18 February 2021

Addendum 1

Morehead City Country Club  
Clubhouse  
Morehead City, NC

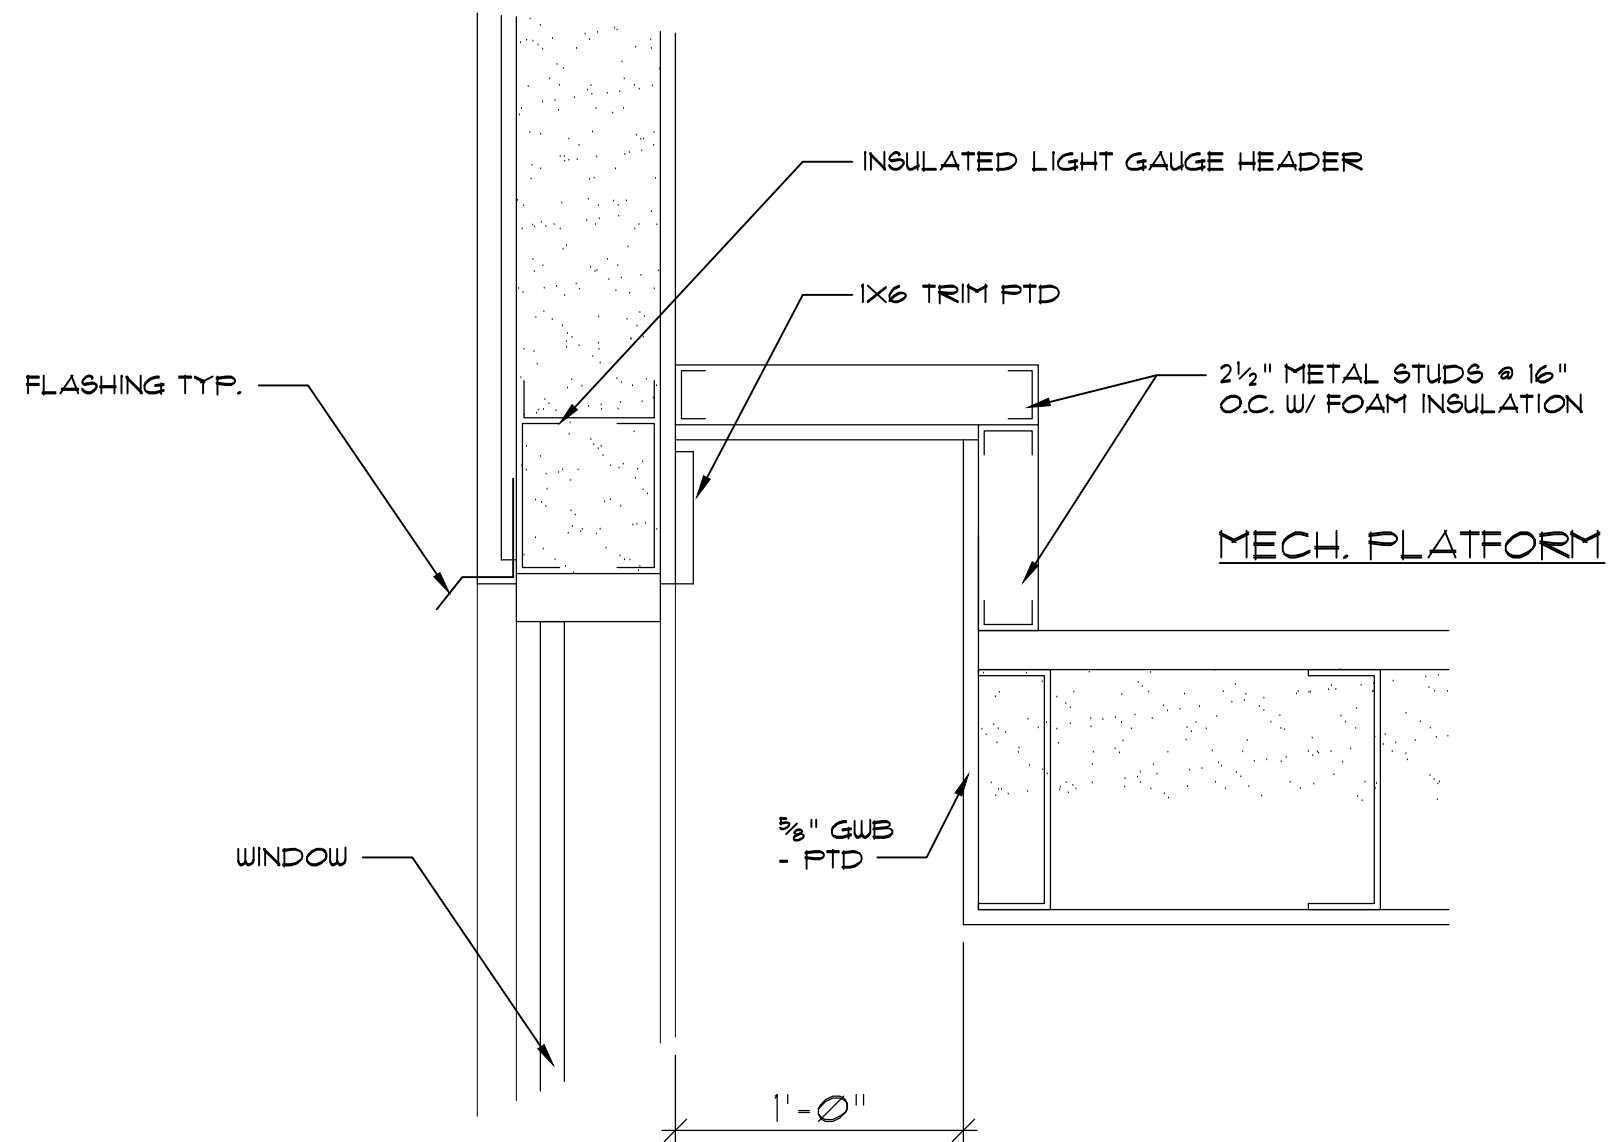
Provide manufacturers required clearance for the stand-by generator in the "Mech Area". Coordinate with GC prior to start of work. Coordinate revised size of enclosure with Architectural plans. Locate 1200-amp service disconnect, CT cabinet and meter base on exterior wall of mech area enclosure. Provide 600 amp NEMA 3R ATS with-in the enclosure. See attached sketch.

# OFFICE WINDOW/MECHANICAL PLATFORM DETAIL

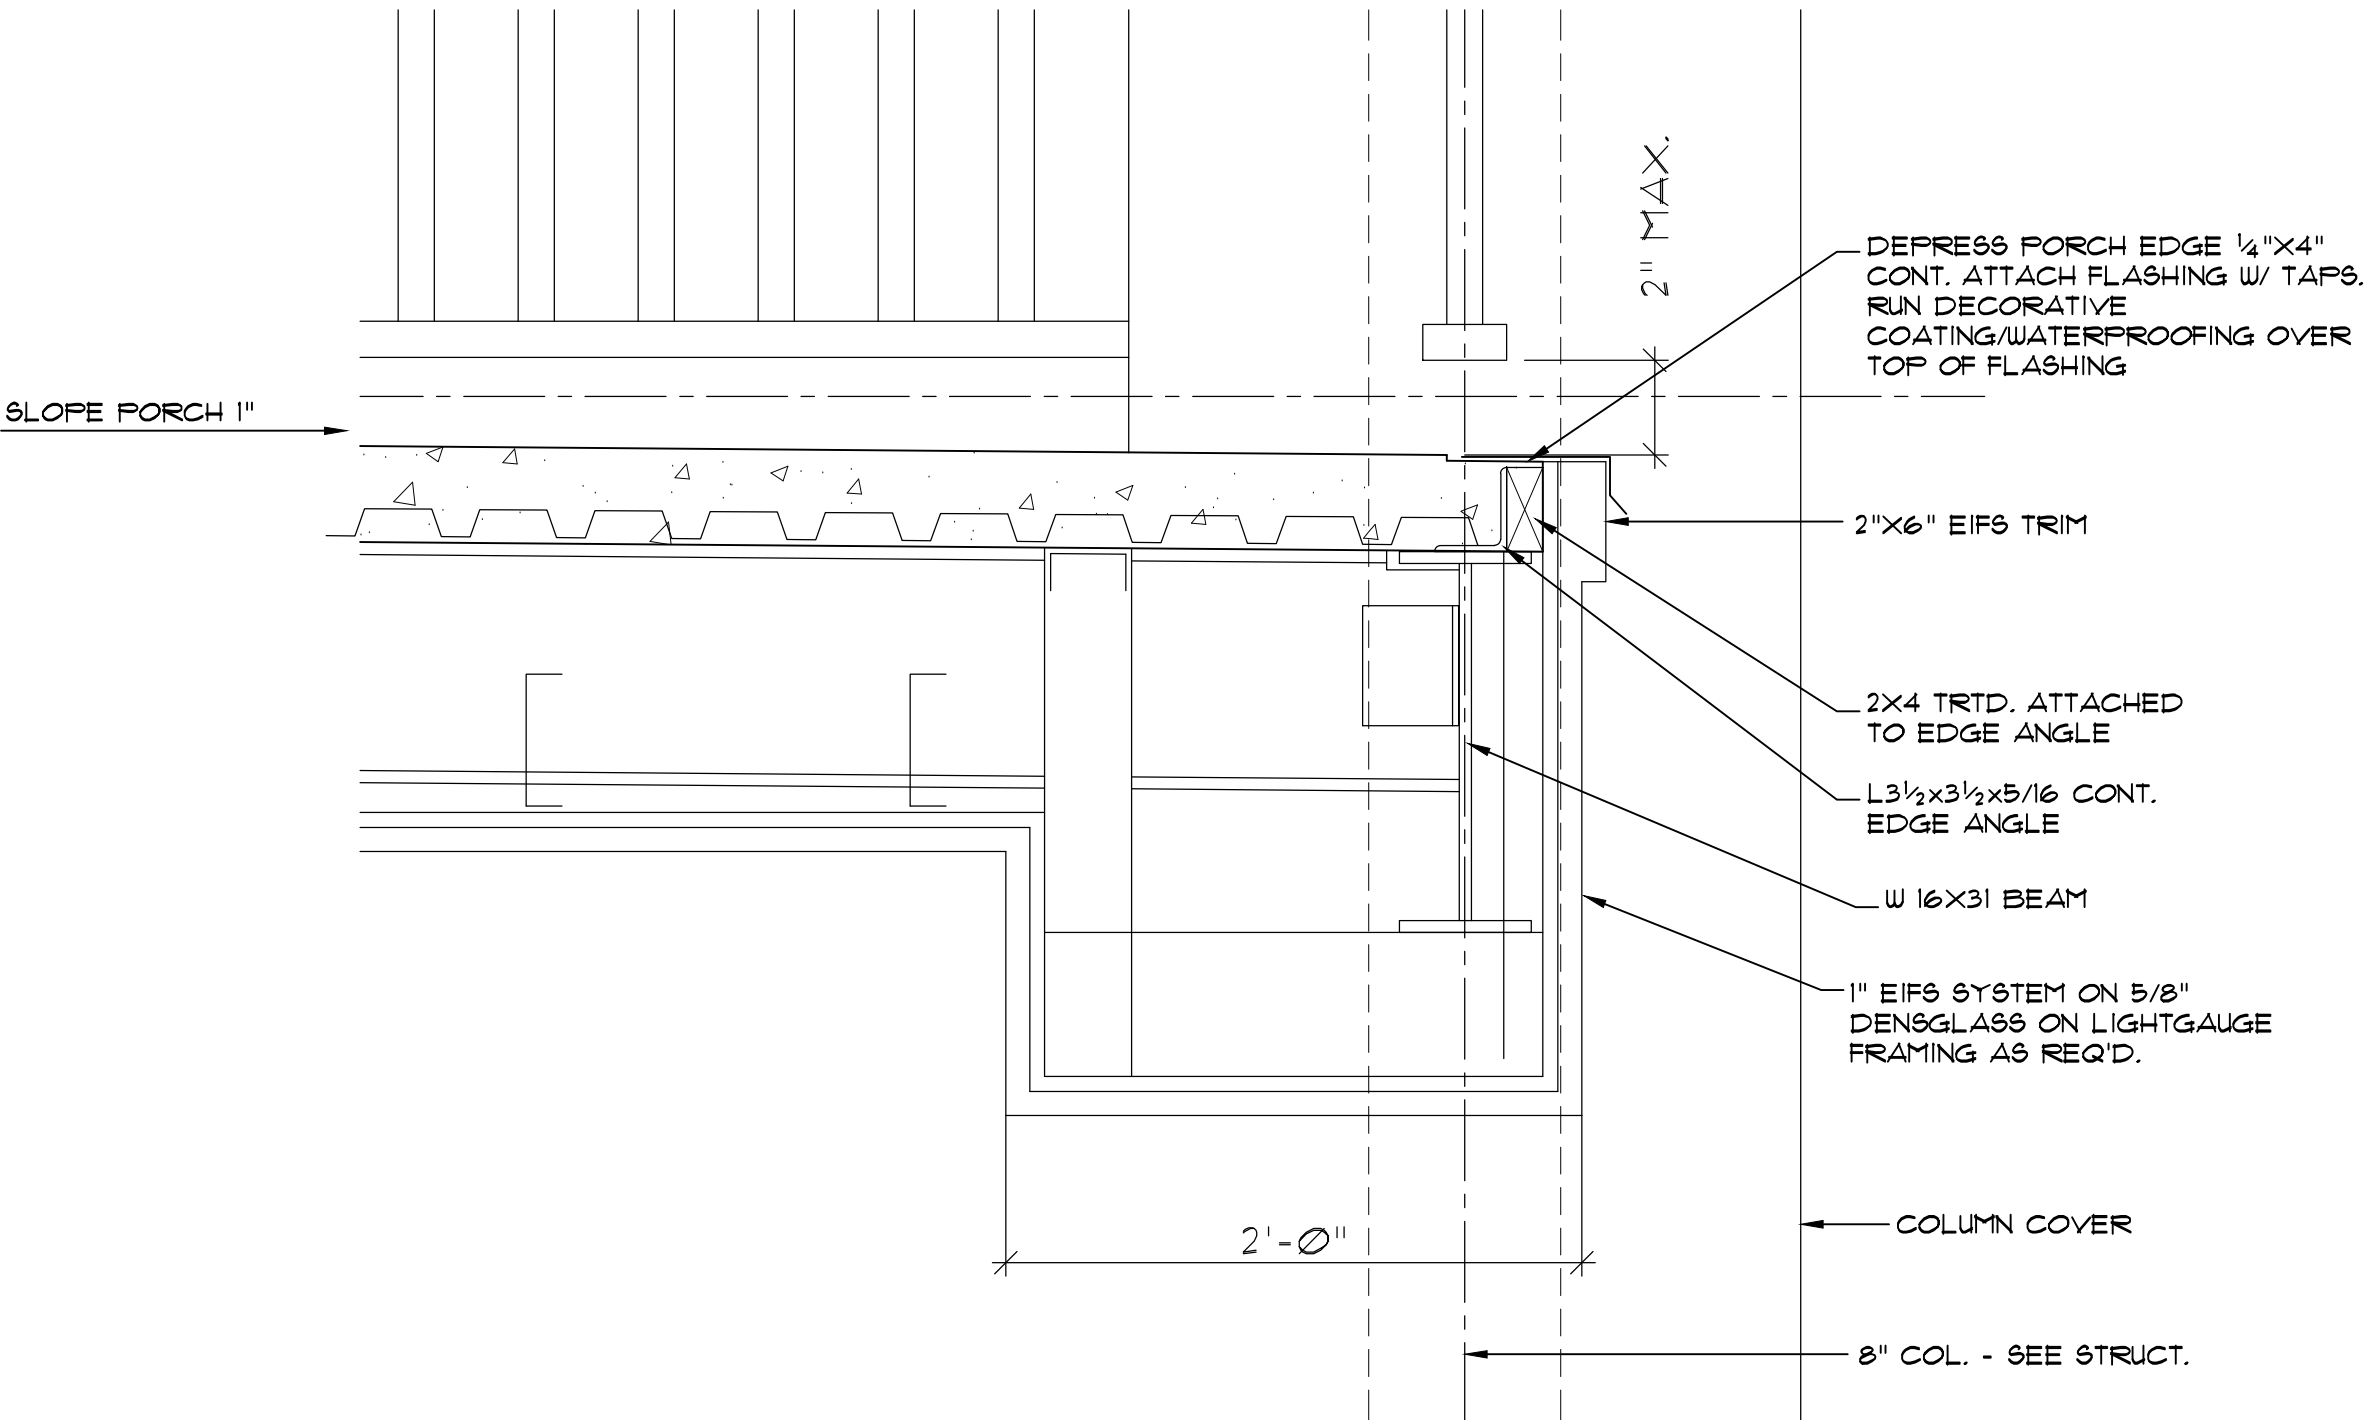
- See attached BD-1 for Office Window/Mechanical Platform Detail.
- See attached BD-2 for Second Level Porch Flashing Detail.
- See attached BD-3 for Revised Men Toilet 305.

# ROOF LADDER

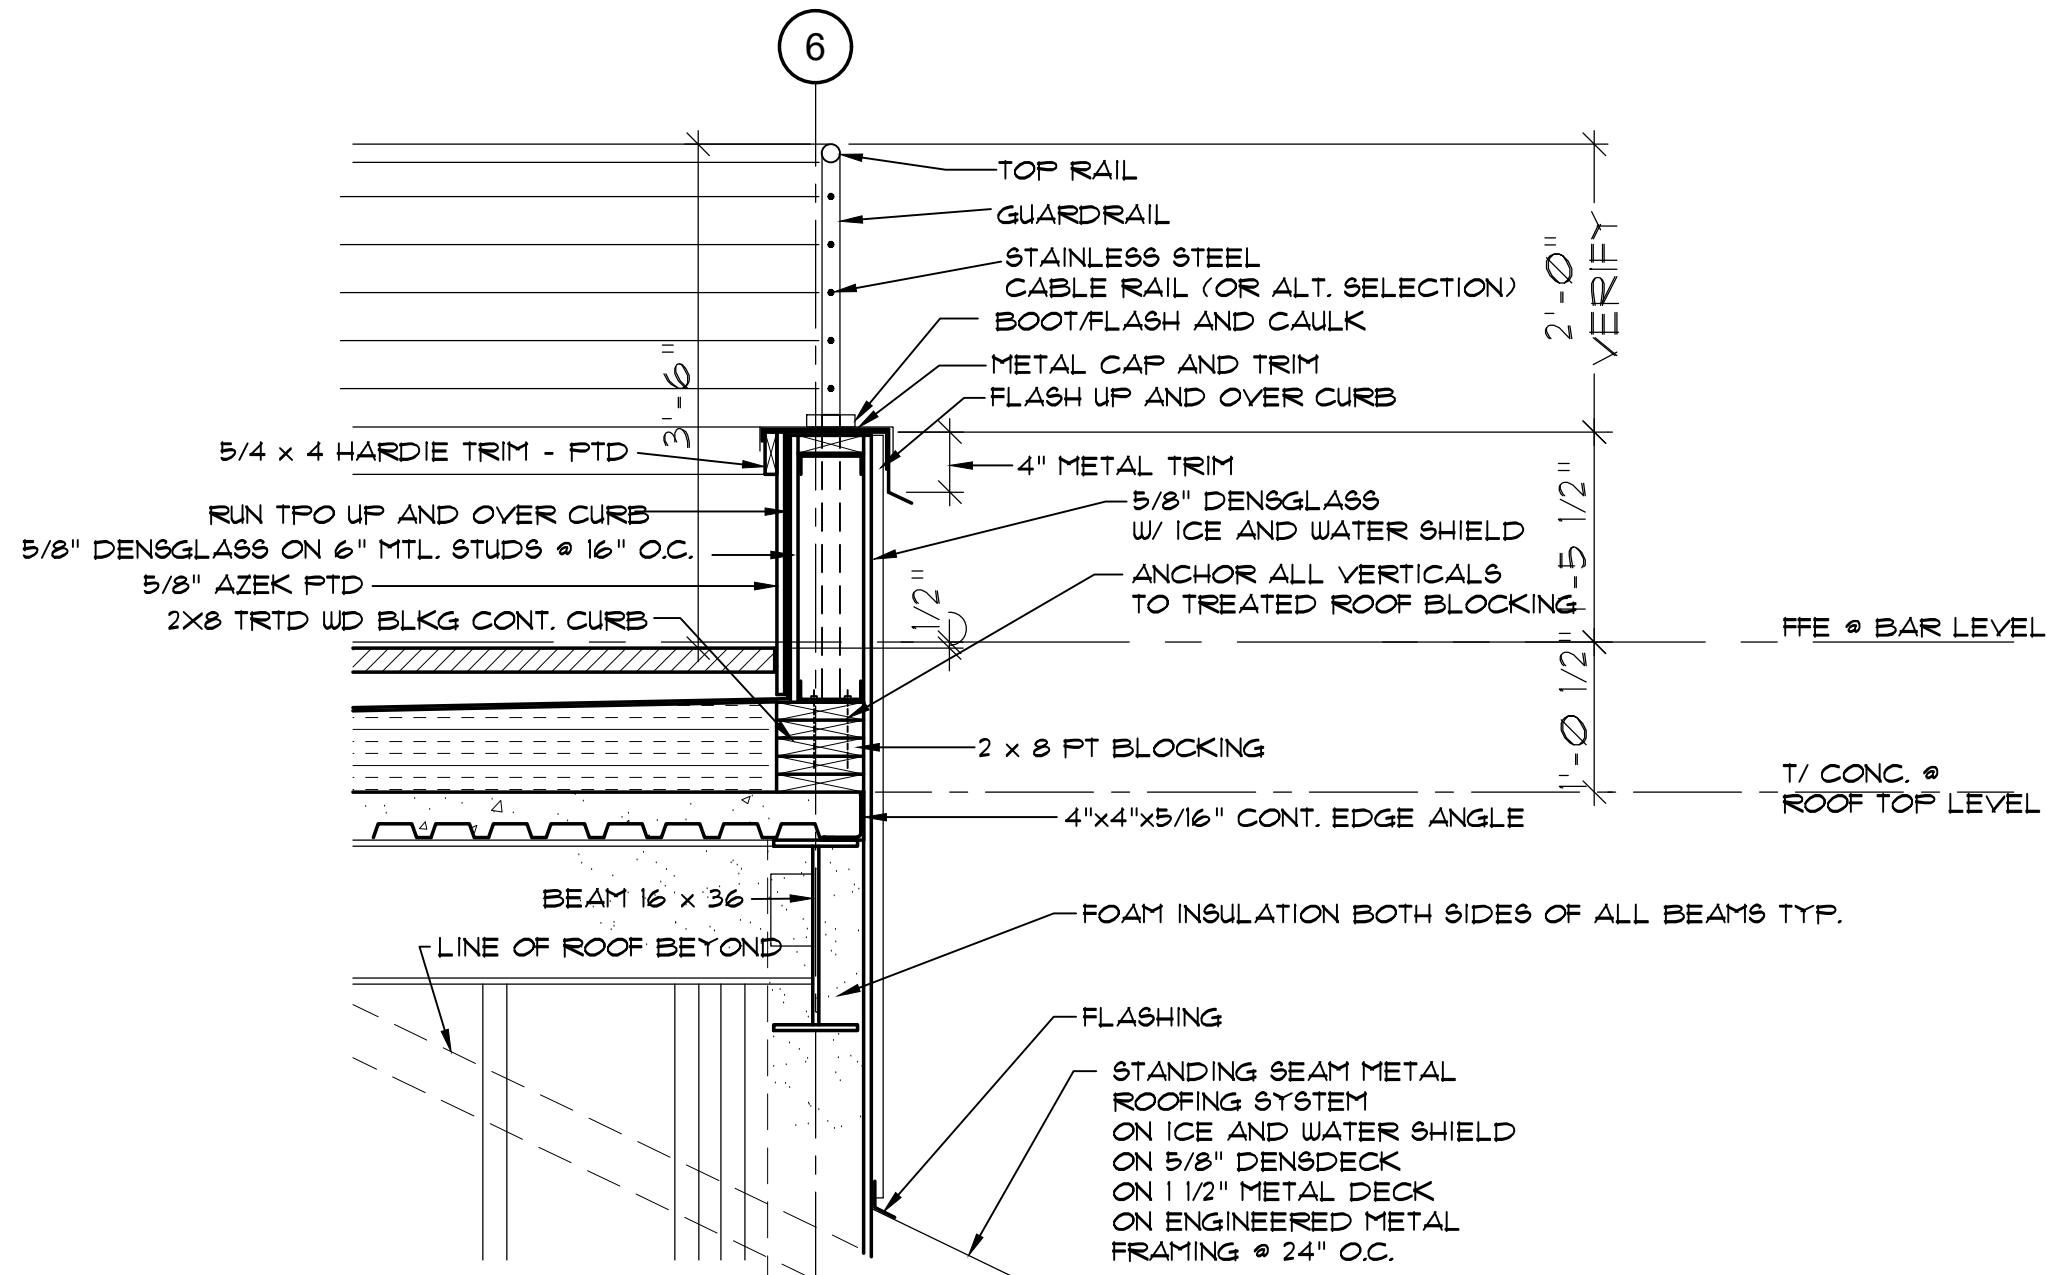
- See attached BD-4 for Roof Ladder Location.
- See attached BD-5 for Revised Perimeter Roof Top Rail Detail.
- Please note BD-6 (clarifications for interior stair) will be issued in Addendum 2.

**PERGOLA DETAIL**

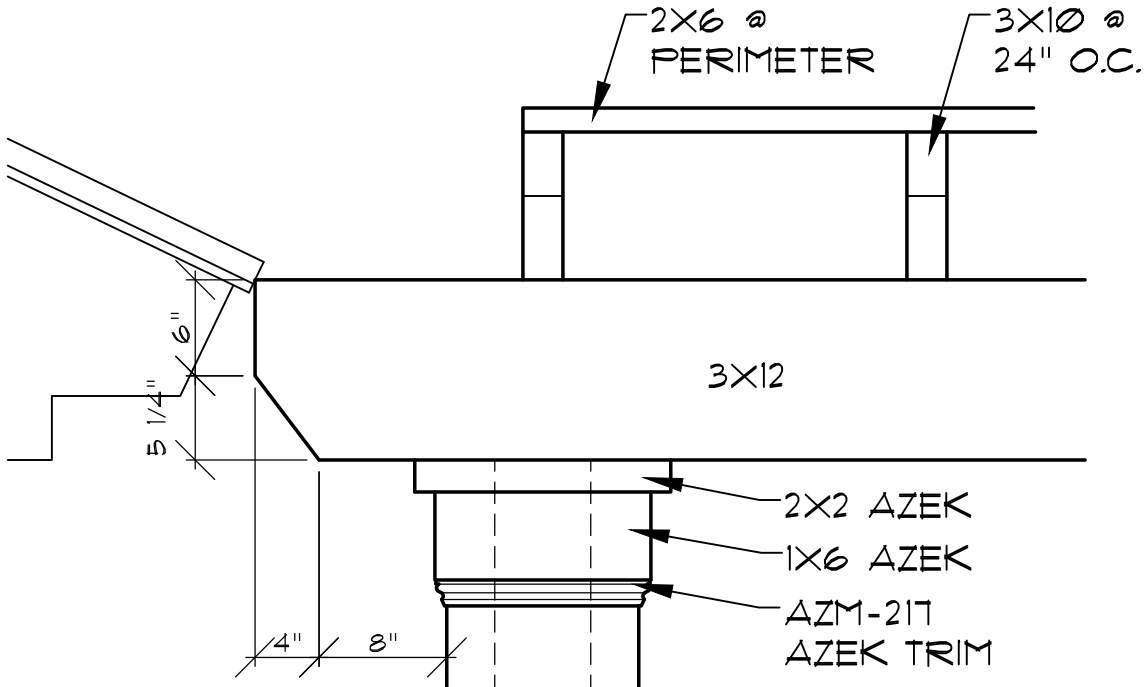
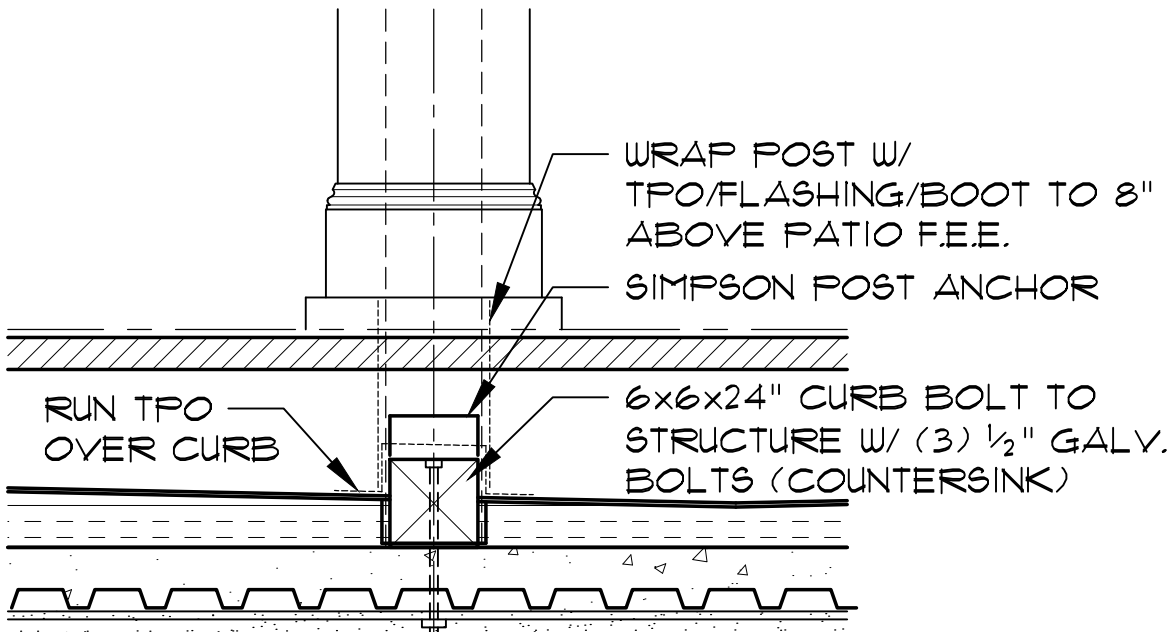
- See attached BD-8 for Pergola Details (reference also A-5.13). Note: Add 6 posts/column covers near wall line 3.6 for Pergola bearing in lieu of bearing on exterior wall. (note: relocate door 302A to allow for installation of new column.)
- Drawing A-5.1: foam insulate raised Bar Floor area at Roof Top Level.
- Generator/Mech. Area to revise from 20'x12' to 20'x28'.
